LUSCOMBE AIRPLANE CORPORATION  
DALLAS 1, TEXAS

SERVICE BULLETIN NUMBER 3-46

SUBJECT: Installation of Rudder Return Springs, Model 8A  
Serial Numbers 1925-3049

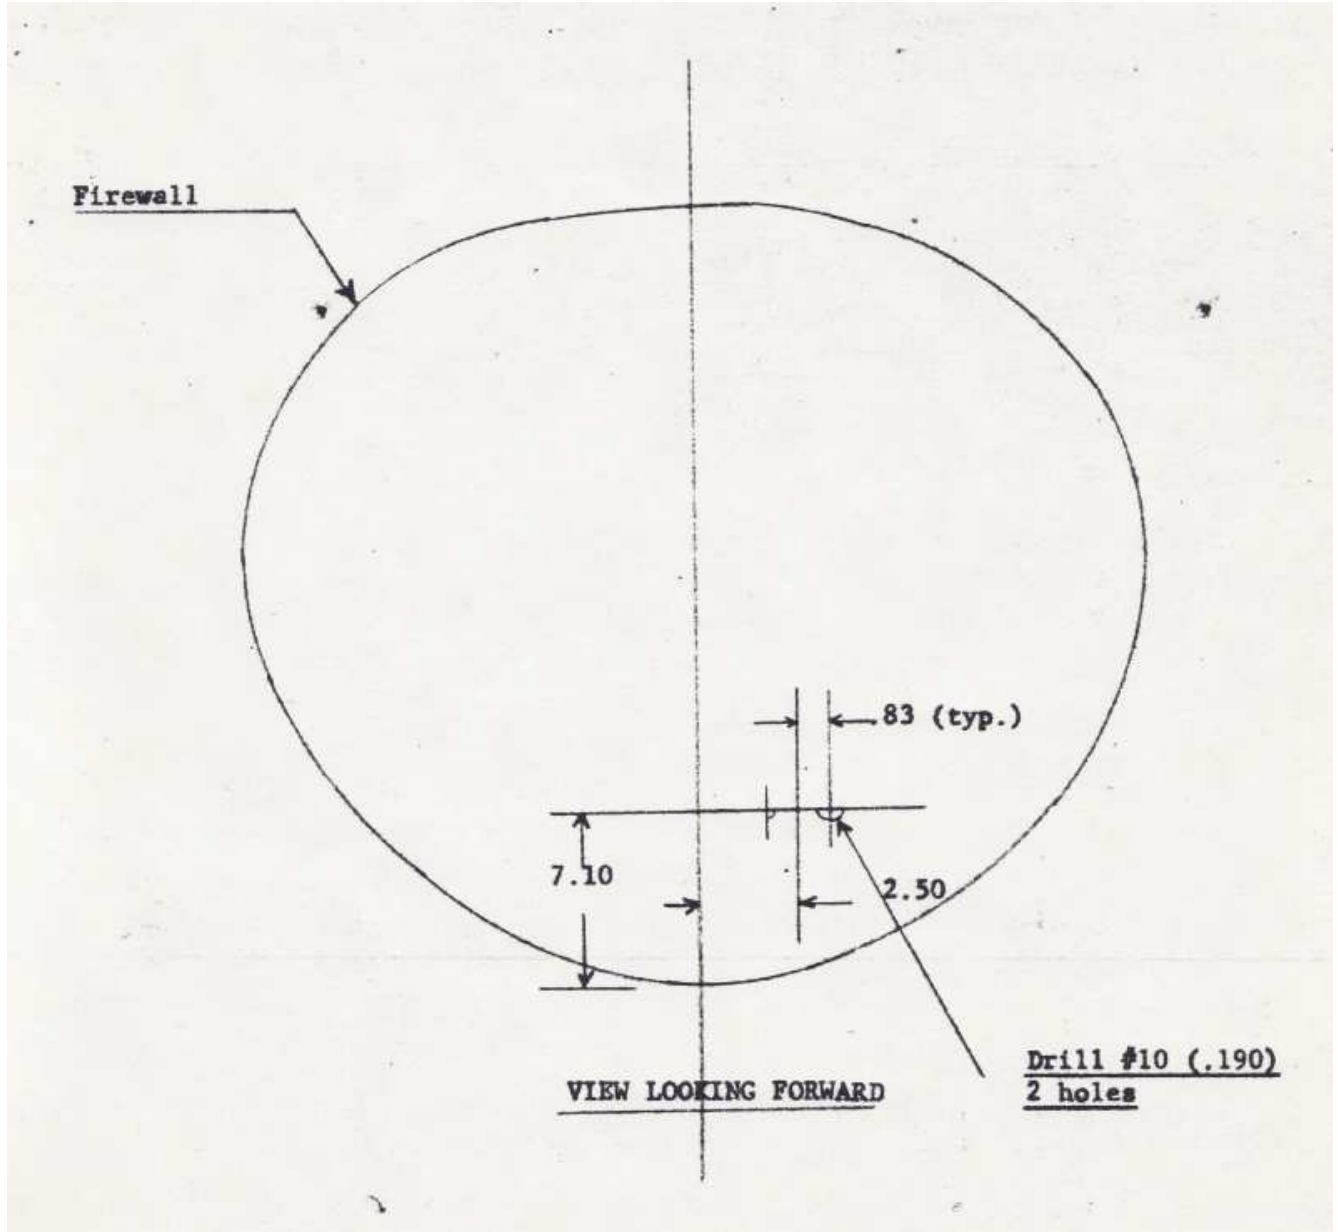
In order to improve the directional stability characteristics of the Model 8A airplane, the changes described below and illustrated in the accompanying drawings are to be made as soon as possible.

1. Drill two #10 (.190) holes in firewall, located as per sketch.
2. Drill one #30 (.1285) hole in each rudder control horn, located as per sketch.
3. Install springs between firewall and rudder control horns, using AN42-6 bolts for connection springs to firewall. The spring tension may be varied slightly by carrying the arrangement of the washers on either side of the firewall until the rudder is held perfectly neutral by the springs.

NOTE: that the left spring is installed with a 1" steel link between the spring and the firewall.
